Plan review re-submittals shall include the following:

3) THE BUILDING CODES ADOPTED BY THE CITY OF NAPERVILLE

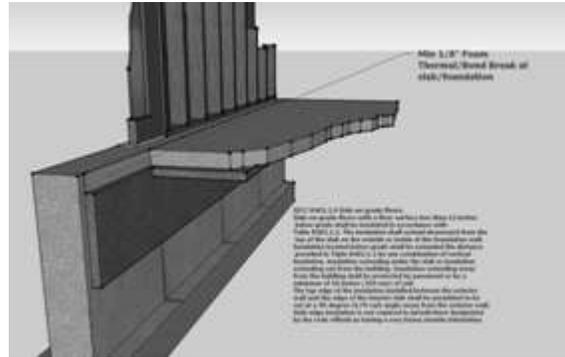
24) **R310.2.1 LADDER AND STEPS**

Window wells with a vertical depth greater than 44 inches below the ground level shall be equipped with a permanently affixed ladder or steps. Ladders or rungs shall have an inside width of at least 12 inches, shall project at least 3 inches from the wall and shall be spaced not more than 18 inches on center.
